New Albany Planning Commission

Monday, September 15, 2025 Meeting Minutes - Approved

FDM-71-2025 Visions Professional Final Development Plan Modification

East Elevation - Approved by the PC

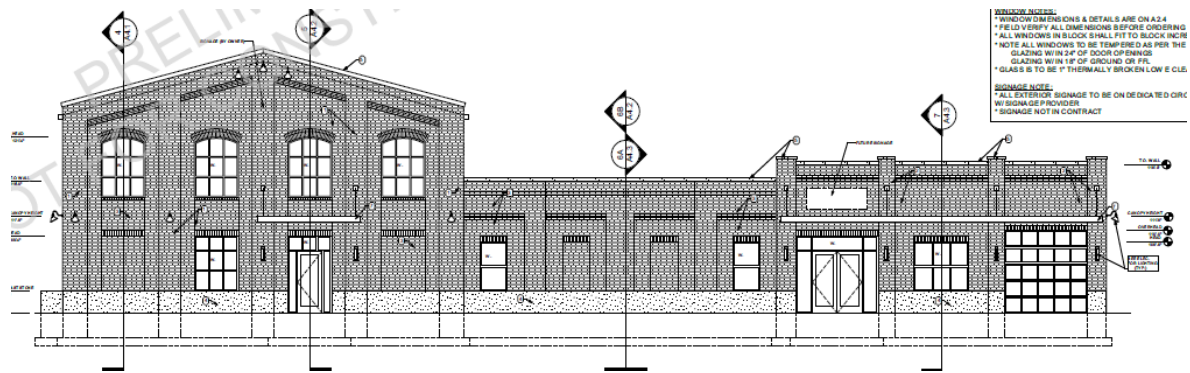
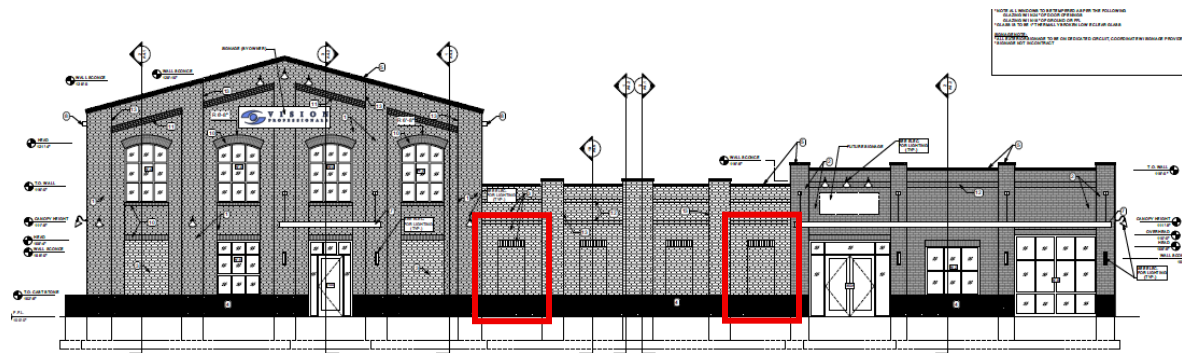
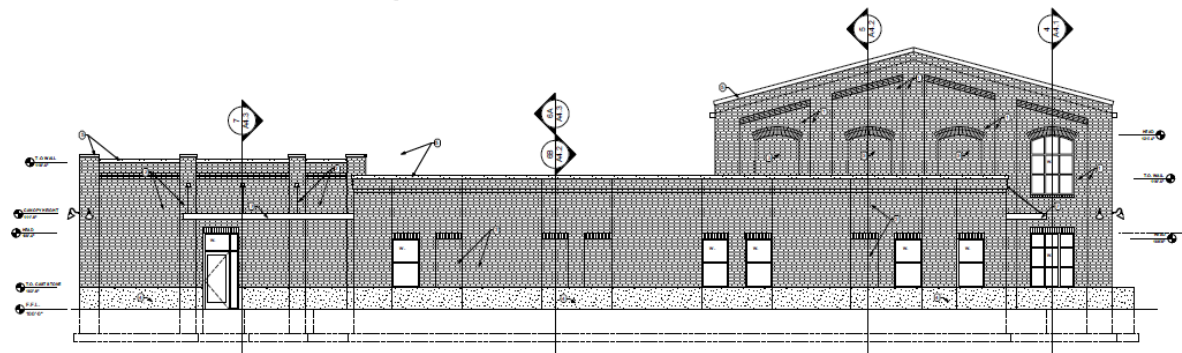
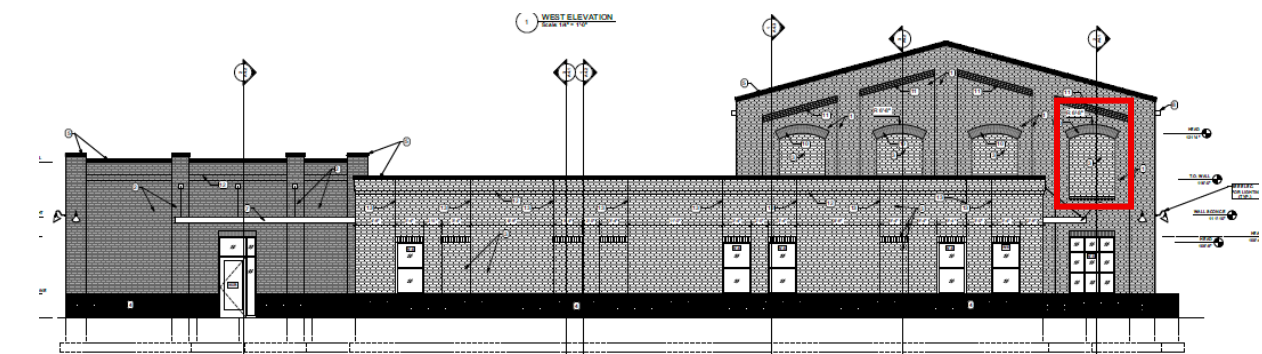
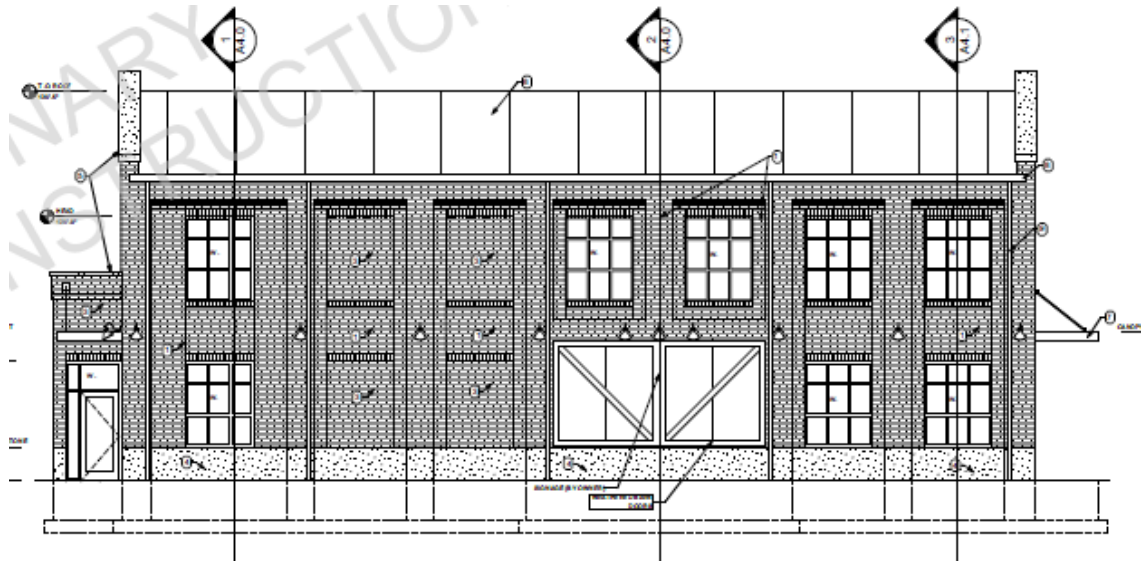
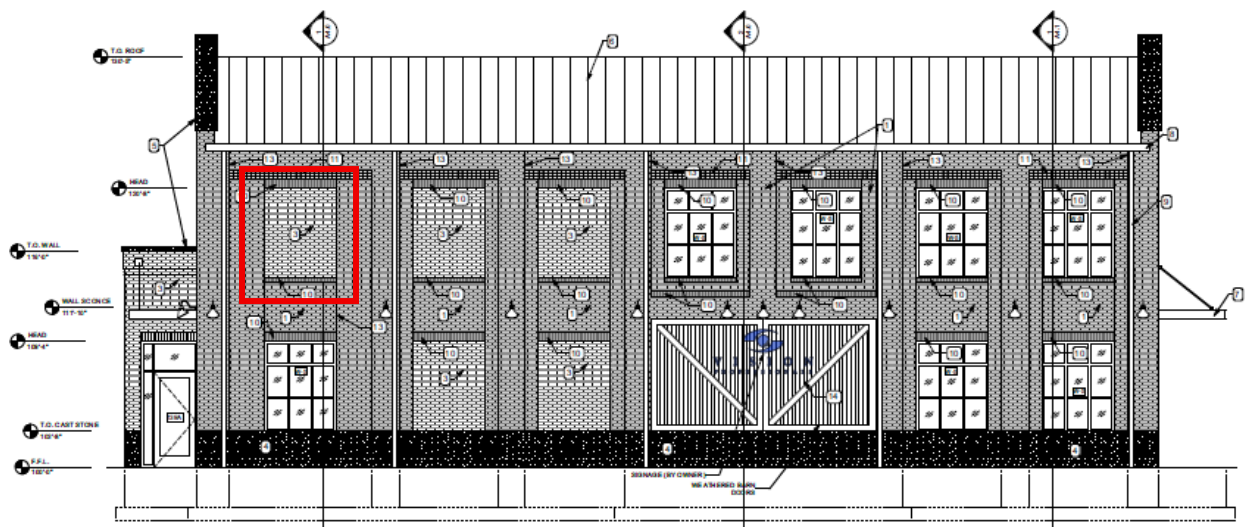
The applicant is requesting minor window modifications on the east, west, and north elevations (see next page, changes shown in red). On the east elevation, the adjustment is due to the rooms being used for optometry, where outside light cannot be permitted. On the west and north elevations, the change results from extending the upper mechanical floor over the breakroom to conceal the unfinished mechanical space from view. Staff does not have any concerns with the request.

Just to note signage shown is not approved. It was conditioned in the original final development plan that all building and site signage must meet city code, the Canini Trust Corp Sign Recommendations Plan and be subject to staff approval.
